1. Type of Well <input type="checkbox"/> Oil Well <input type="checkbox"/> Gas Well <input checked="" type="checkbox"/> Other: INJECTION		5. Lease Serial No. NMLC063458
2. Name of Operator CONOCOPHILLIPS COMPANY / Contact: RHONDA ROGERS E-Mail: rogerr@conocophillips.com		6. If Indian, Allottee or Tribe Name
3a. Address MIDLAND, TX 79710	3b. Phone No. (include area code) Ph: 432-688-9174	7. If Unit or CA/Agreement, Name and/or No. 892000601H NM 71052H
4. Location of Well (Footage, Sec., T., R., M., or Survey Description) Sec 34 T20S R38E NESW 1980FSL 1980FWL		8. Well Name and No. WARREN UNIT 75
		9. API Well No. 30-025-26312-00-S1
		10. Field and Pool, or Exploratory WARREN
		11. County or Parish, and State LEA COUNTY, NM

Warren Unit Blinebry Tubb WF 75
API #30-025-26312
Isolate and Repair casing Leak and RTI

ConocoPhillips Company
Warren Unit - 75, API 2526312
T20S-R38E, Sec 34, 1980FSL & 1980FWL
June 17, 2015

Schematic - Current

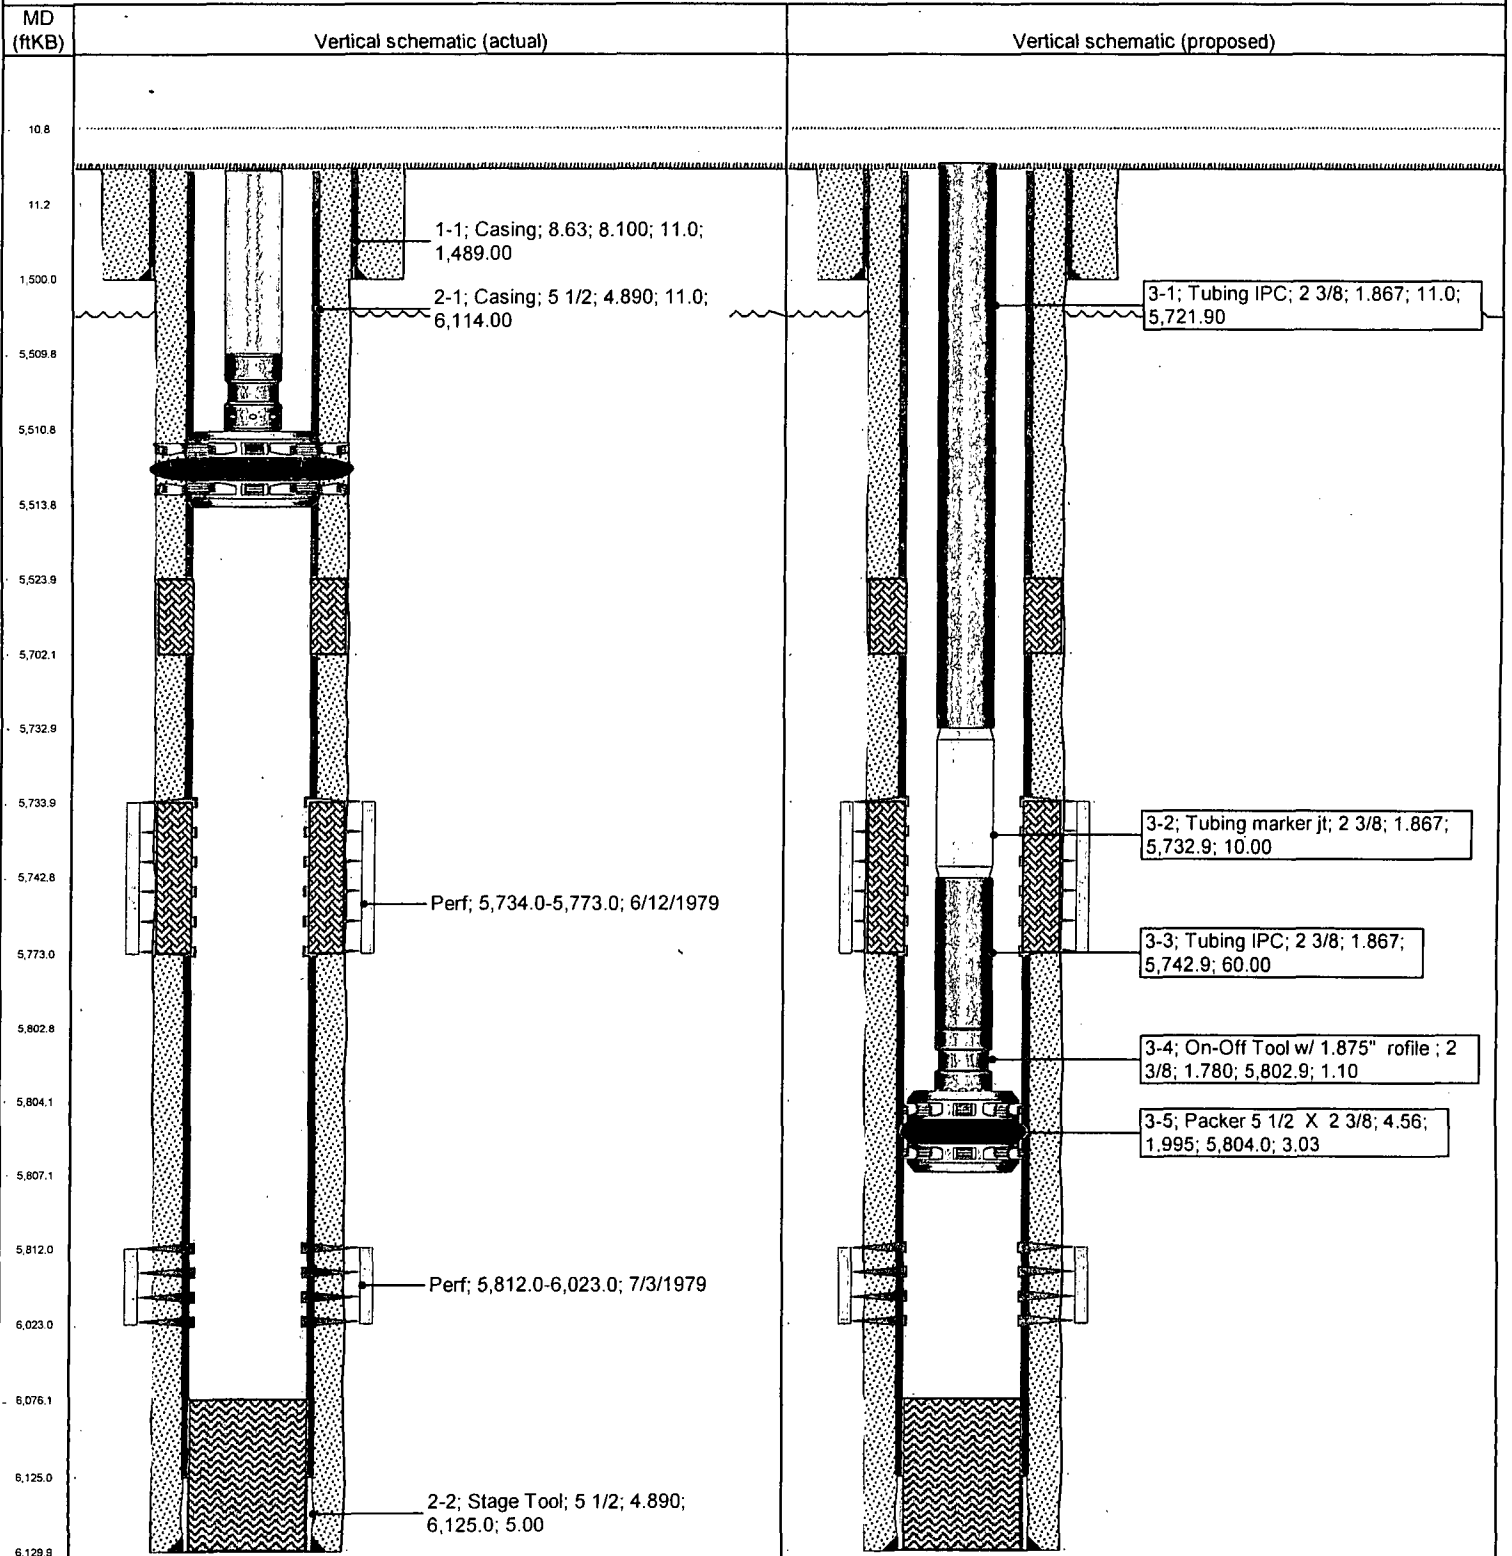
1. Due to being within the Lesser Prairie Chicken habitat, this workover activity will be restricted to the hours of 9:00am through 3:00am for the period of March 1 through June 15. Exceptions to these restrictions may be granted by BLM's Johnny Chopp <jchopp@blm.gov> 575.234.2227 or Bob Ballard <bballard@blm.gov> 575.234.5973.

2. Before casing or a liner is added, replaced, or repaired prior BLM approval of the design is required. Use notice of intent Form 3160-5.
3. Subject to like approval by the New Mexico Oil Conservation Division.

4. Use of class "H" cement at depths greater than 7500ft & "C" at depths less than 7500ft will be necessary. Class "C" squeeze cement is to be mixed 14.8#/gal, 1.32 ft³/sx, 6.3gal/sx water and "H" mixed 16.4#/gal, 1.06ft³/sx, 4.3gal/sx water.

5. **Provide BLM with an electronic copy (Adobe Acrobat Document) cement bond log record from 5790 or below to top of cement taken with 0psig casing pressure. The CBL may be attached to a pswartz@blm.gov email. The CFO BLM on call engineer may be reached at 575-706-2779.**

11. After drilling out the squeeze plug, **perform a charted casing integrity test** of 1000psig minimum. Document the pressure test on a one hour full rotation calibrated (within 6

months) recorder chart registering within 25 to 85 per cent of its full range. **Verify all annular casing vents are plumbed to the surface and open during this pressure test. Call BLM 575-393-3612 and arrange for a BLM witness of that pressure test.** Include a copy of the chart in the subsequent sundry for this workover.

- 2) Set the **injection packer below** the old Paddock perforations of 5734-71.
- 3) The minimum test pressure should be 500 psig for 30 minutes or 300 psig for 60 minutes, with minimum 200 psig differential between tubing and casing pressure (at test time) but no more than 70% of casing burst pressure as described by Onshore Order 2.III.B.1.h. (The tubing or reservoir pressure may need to be reduced). Verify all annular casing vent valves are open to the surface during this pressure test. An alternate method for a BLM approved MIT is to have the fluid filled system open to atmospheric pressure and have a loss of less than five barrels in 30 days witnessed by a BLM authorized officer.
